CITY OF PORTLAND, MAINE
DEVELOPMENT REVIEW APPLICATION
PLANNING DEPARTMENT PROCESSING FORM
Planning Copy

2001-0282
Application I. D. Number
10/9/01
Application Date
17 Garrison Street
Project Name/Description

RE: Minor Site Plan/17 Garrison Street
ID#2001-0282 / CBL#213B001

SITE PLAN

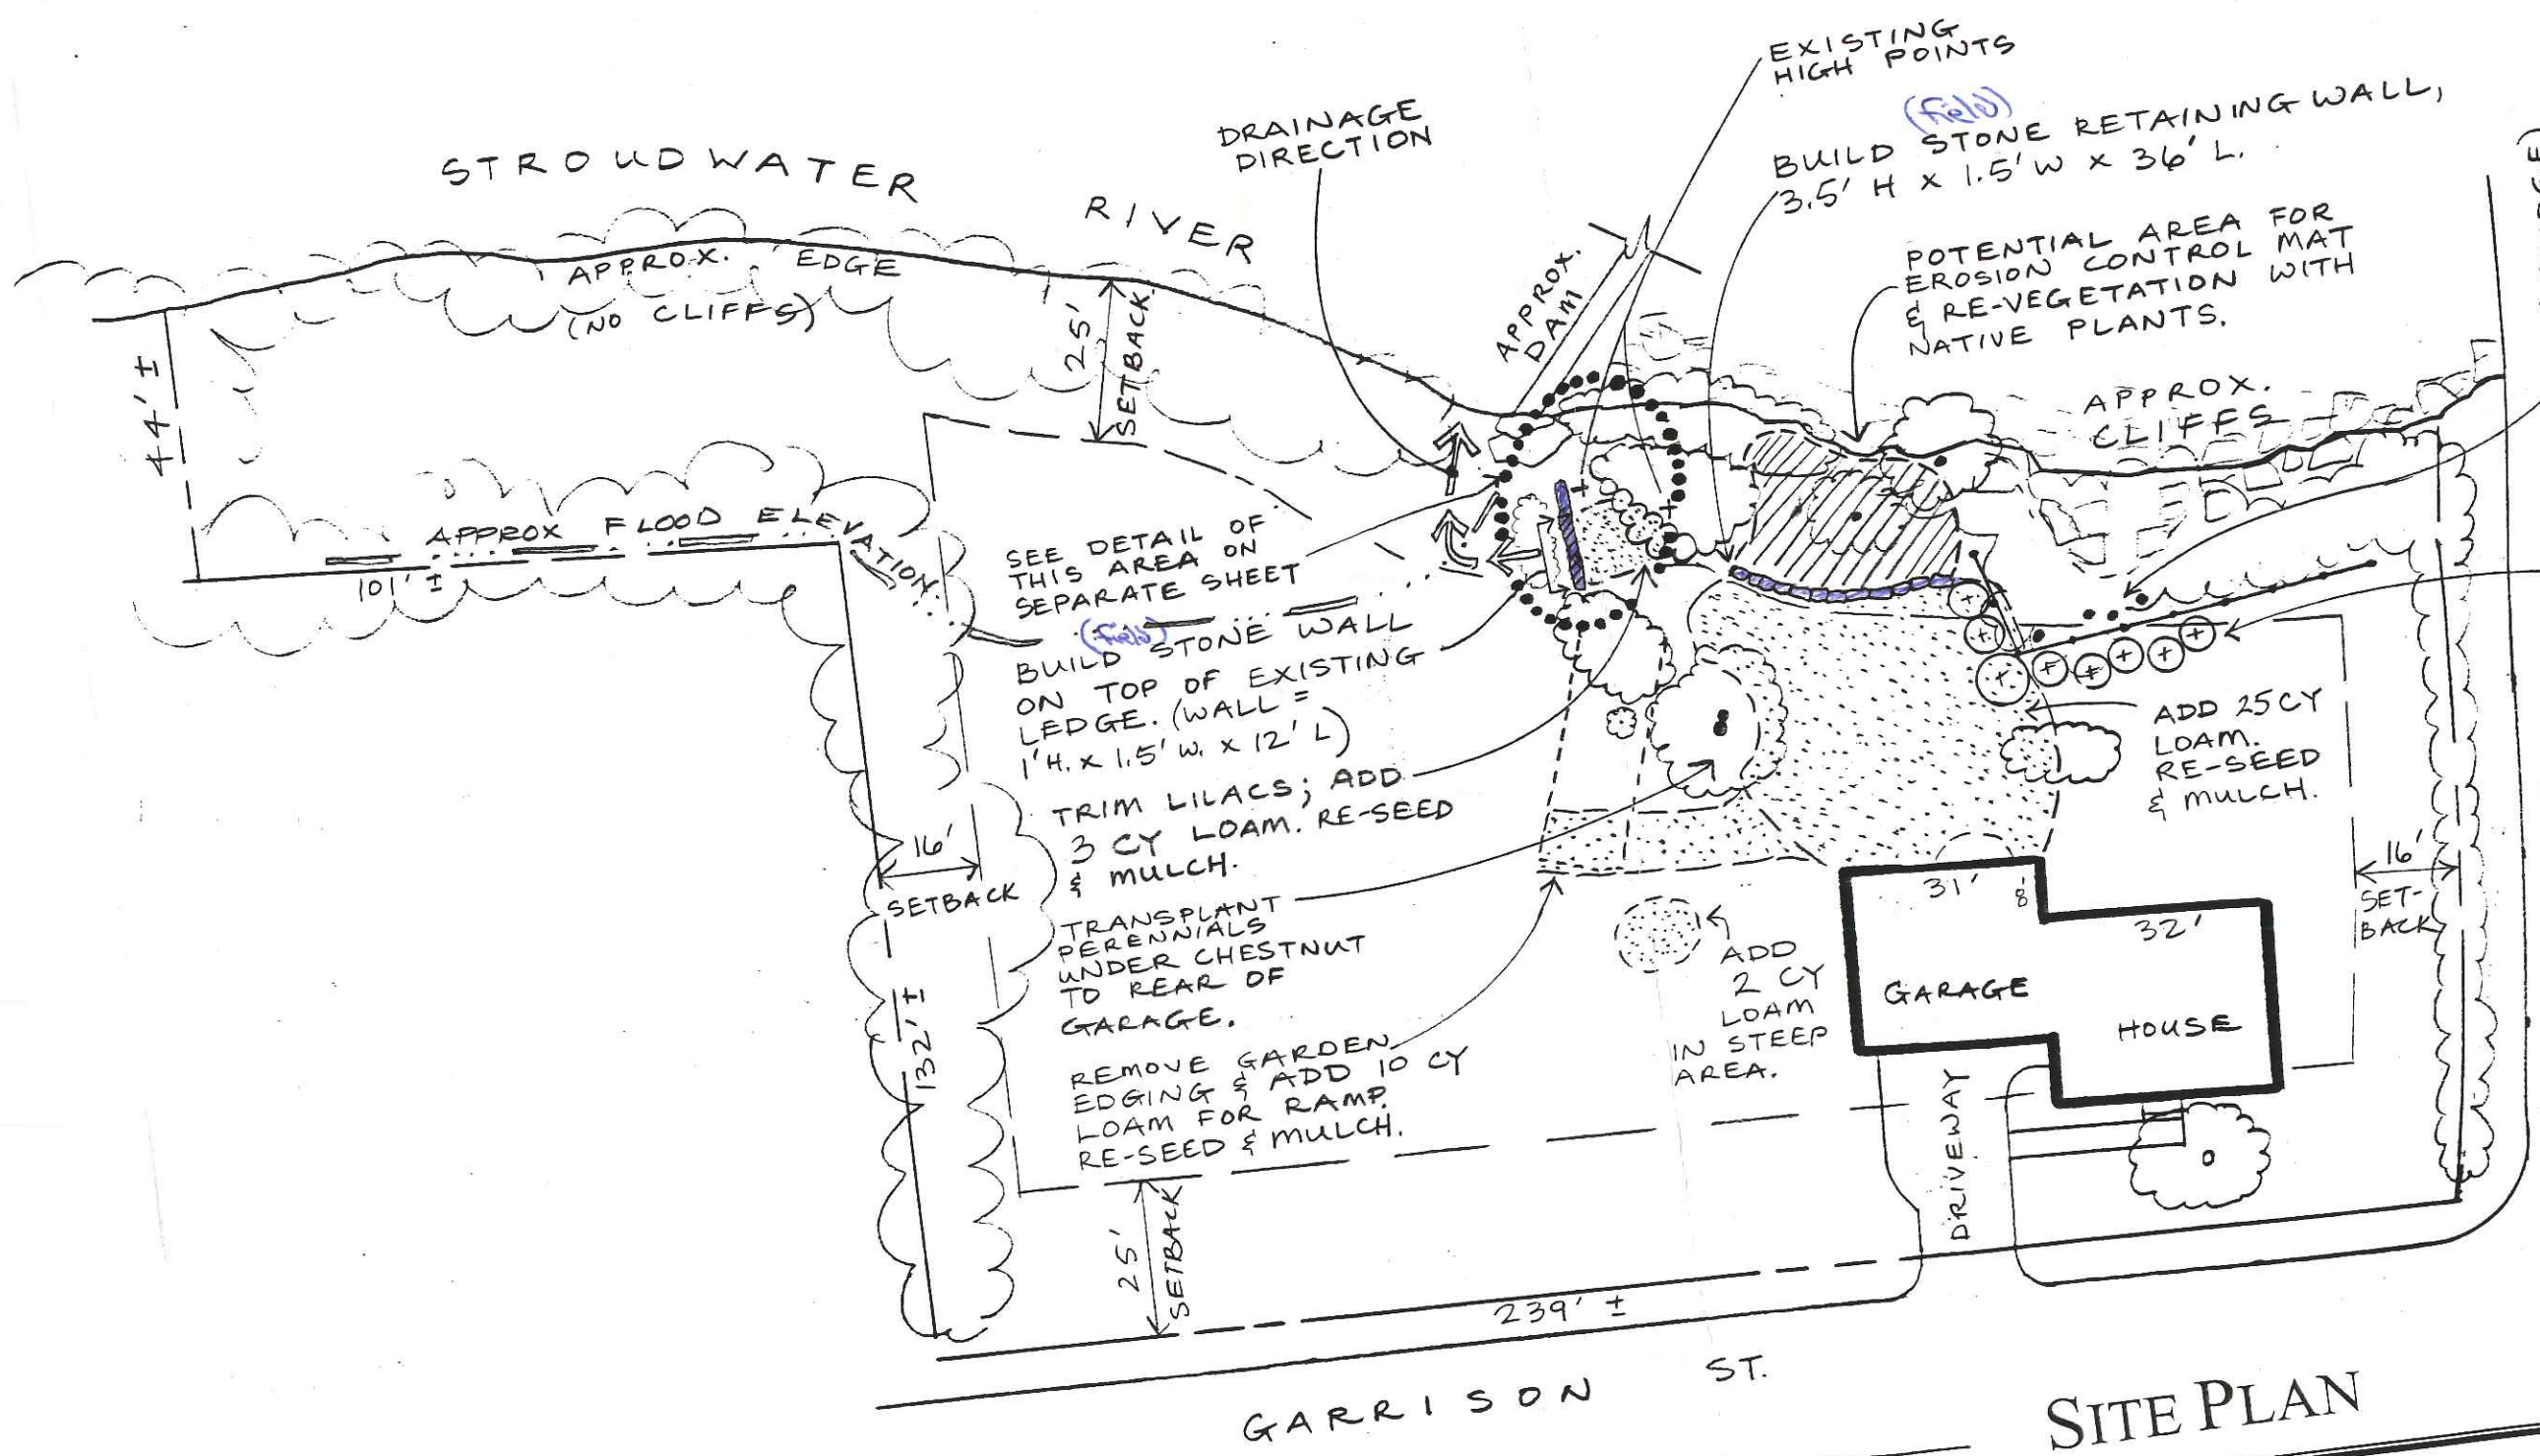
Wall in Shoreland (within 100 ft)?
Remains trees in SLZ?
Stone wall vs. drainage direction?
Any other Permittives?

As promised during our phone conversation this morning, I enclose a revised set of plans for the Witt/Okrent residential project at 17 Garrison Street, at the Stroudwater Dam. They show the new restraint solution near the dam of an extended wooden grape arbor, rather than an iron railing.

In line with your request on the phone, I have calculated the basal area of the trees to be removed and to remain within 75 feet of the Stroudwater River on this lot. The basal area of the four Norway Maples to be removed totals 130 square inches, or 6.3 percent of the total basal area of all trees four inches at breast height within 75 feet of the river on this lot, which total area is 2068 square inches.
